SNOWY VALLEYS COUNCIL SUPPLEMENTARY REPORT – SOUTHERN REGIONAL PLANNING PANEL

Panel Reference	PPSSTH-25
DA Number	2019/0172
LGA	Snowy Valleys Council
Proposed Development	Increase general solid (non-putrescible) waste from 5,000 tonnes per annum to a limit of 40,000 tonnes per year resulting in the increased total amount of waste accepted at the landfill from 400,000 to 900,000 tonnes.
Street Address	10 Killarney Road, Gilmore NSW
Applicant/Owner	Allspec & Partners Pty. Limited/John & Gail Bellette
Date of DA lodgement	15 November 2019
Number of Submissions	One submission from a member of the public has been received in response to the exhibition of the application.
Recommendation	That DA2019/0172 be approved subject to conditions.
Regional Development Criteria (Schedule 7 of the SEPP (State and Regional Development) 2011	<p>Particular designated development in accordance with:</p> <p>32. Waste management facilities or works</p> <p>(1) Waste management facilities or works that store, treat, purify or dispose of waste or sort, process, recycle, recover, use or reuse material from waste and—</p> <p>(a) that dispose (by landfilling, incinerating, storing, placing or other means) of s

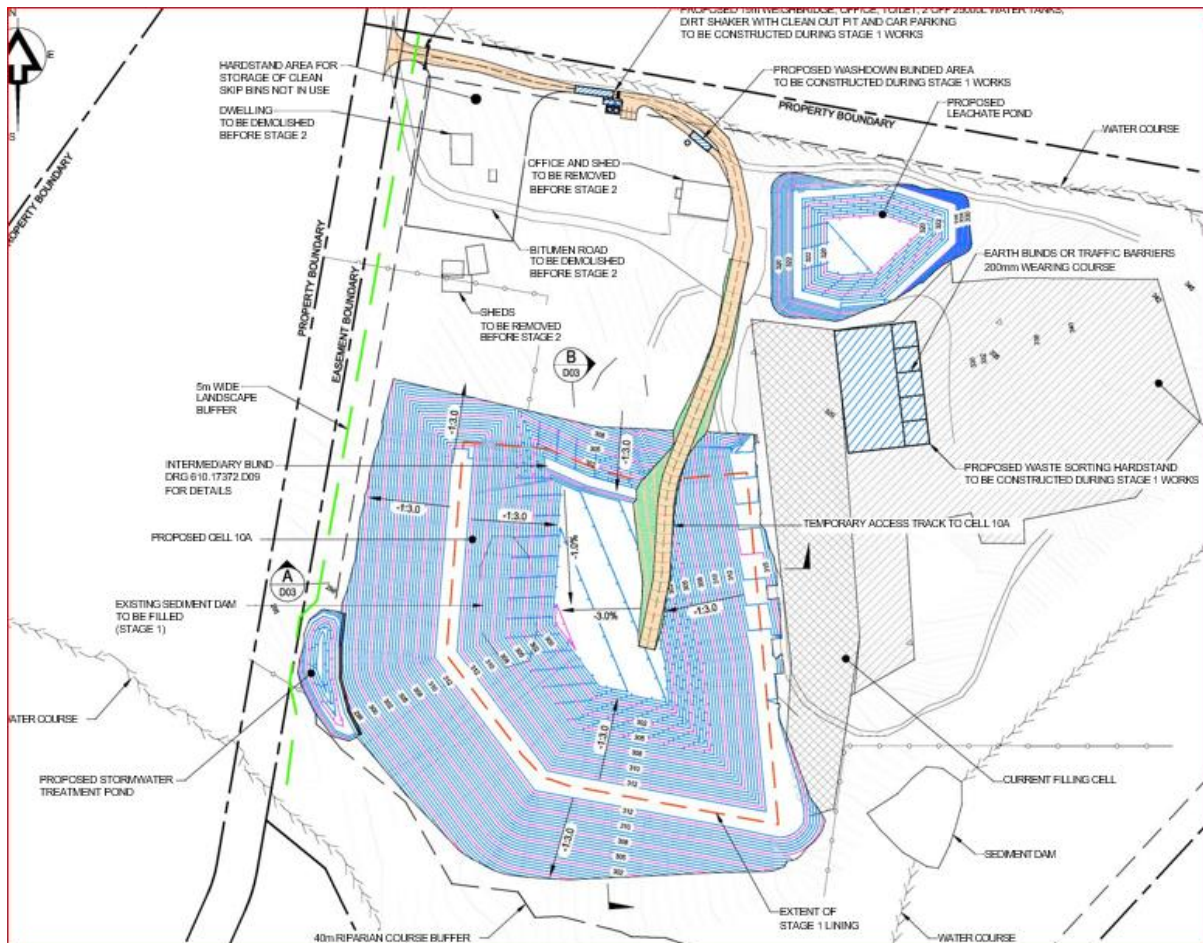
'As outlined below, the proposed Development does not coincide with any Environmentally Sensitive Areas listed in Table 1 of the DUAP EIS Landfilling Guideline (1996), specifically in relation to surface and groundwater resources.

2.1 Surface Water

The Development site is not located in or within 40 metres of a permanent or intermittent waterbody (including rivers, lakes, bays or wetlands). The only waterbody located near to the Development site is a small ephemeral creek (Killarney Creek), as described in Section 2.11.1 of the EIS. As indicated by the Drawings there is a 40m buffer between this water body and the Development boundary.' (See drawing immediately below).
